Preliminary Drainage Report

Overlook at Homestead Subdivision El Paso County, Colorado

Prepared: December 4, 2023

OVERLOOK FILING NO. 1
 EL PASO COUNTY, COLORADO
 PRELIMINARY DESIGN PLANS
 EXCLUSION EXHIBIT DRAINAGE MAP

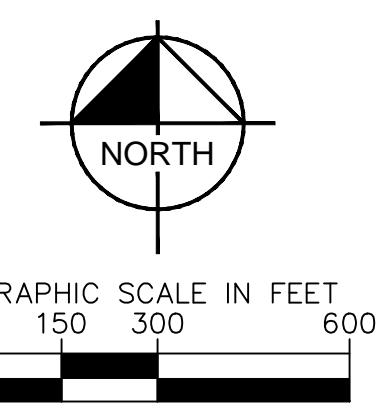
Please shade areas utilizing the large lot exclusion, treated areas, and any basins that will not be developed (ie existing off-site basins not effected by the project). So it is clear the areas that will be treated and all exempt areas including the excluded areas.
